Well Name: BANDANA BNA FEDERAL	Well Location: T22S / R24E / SEC 20 / SENE /	County or Parish/State: EDDY / NM
Well Number: 1	Type of Well: CONVENTIONAL GAS WELL	Allottee or Tribe Name:
Lease Number: NMNM54840	Unit or CA Name:	Unit or CA Number:
US Well Number: 300152731300S1	Well Status: Gas Well Shut In	Operator: EOG RESOURCES INCORPORATED

Notice of Intent

API: 30-015-27313

EOG Resources, Inc. plans to plug and abandon this well as follows:

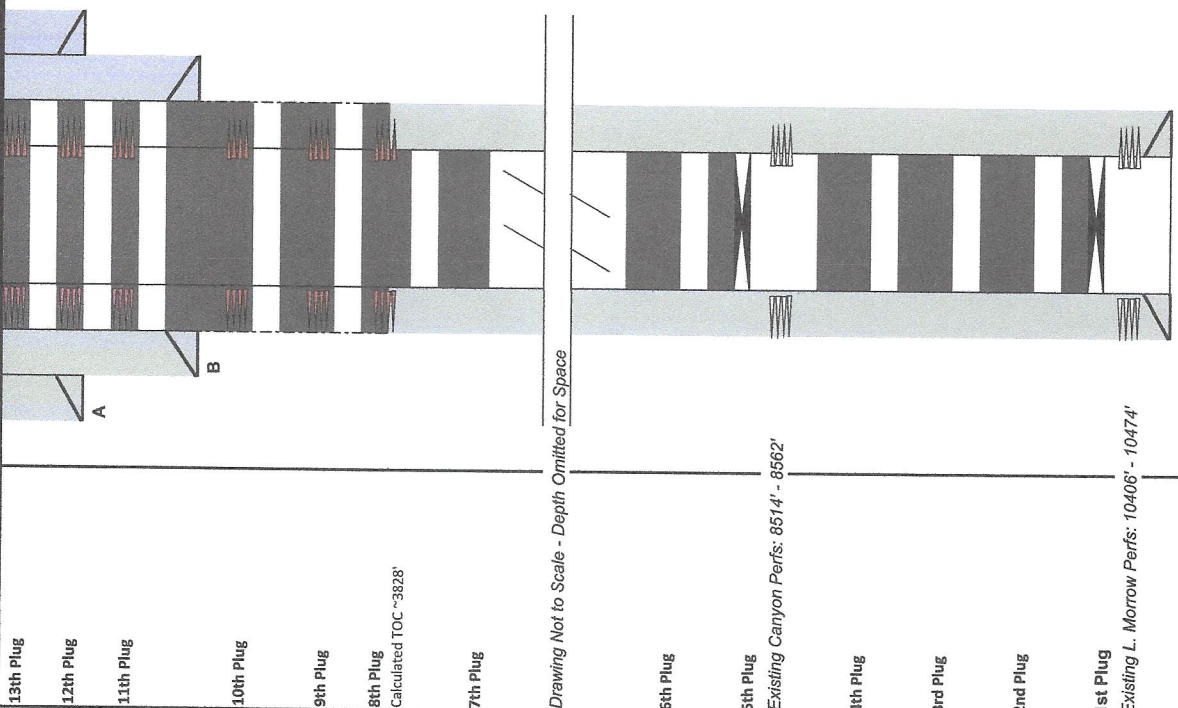
1. MIRU all safety equipment as needed. NU BOP. POOH with production equipment.
2. Set a CIBP at 10,356 ft with ~~4~~ <sup>10 sx</sup> sx Class H cement on top to 10,321 ft. WOC and tag. This will cover Morrow perms.

3. Spot a ~~25~~ <sup>35 sx</sup> sx Class H cement plug from 10,281 ft – ~~10,061~~ <sup>10,020'</sup> ft. This will cover Morrow top.
4. Spot a 25 sx Class H cement plug from 9699 ft – 9479 ft. This will cover Atoka top.

5. Spot a 25 sx Class H cement plug from 9240 ft – 9020 ft. This will cover L. Strawn top.
6. Set a CIBP at 8464 ft with ~~4~~ <sup>10 sx</sup> sx Class H cement on top to 8429 ft. This will cover Canyon perms. *Leak test CIBP*

7. Spot a ~~25~~ <sup>35 sx</sup> sx Class H cement plug from 7724 ft – ~~7504~~ <sup>7487'</sup> ft. This will cover Wolfcamp top.
8. Spot a 25 sx Class C cement plug from 4504 ft – 4257 ft. This will cover cased hole plug spacing limit of 3000 ft.

9. Perforate at 3897 ft. Spot a 28 sx Class C cement plug from 3897 ft – 3759 ft. WOC and tag. This will cover TOC.
10. Perforate at 3331 ft. Spot a ~~39~~ <sup>45 sx</sup> sx Class C cement plug from 3331 ft – ~~3199~~ <sup>3182</sup> ft. WOC and tag. This will cover Bone Spring top. *(In/out)*

11. Perforate at 2784 ft. Spot a ~~57~~ <sup>60 sx</sup> sx Class C cement plug from 2784 ft – 2590 ft. WOC and tag. This will cover Glorieta top and intermediate casing. *(In/out)*

12. Perforate at 1239 ft. Spot a 33 sx Class C cement plug from 1239 ft – 1127 ft. WOC and tag. This will cover San Andres top.
13. Perforate at 384 ft. Spot a ~~31~~ <sup>120 sx</sup> sx Class C cement plug from 384 ft – ~~282~~ <sup>surface</sup> ft. WOC and tag. This will cover surface casing shoe. *(In/out)*

14. ~~Perforate at 100 ft. Spot a 30 sx Class C cement plug from 100 ft up to surface. WOC and tag.~~ *Verify @ surface*  
~~Back fill as needed.~~
15. Cut off wellhead and install dry hole marker. Clean location as per regulated.
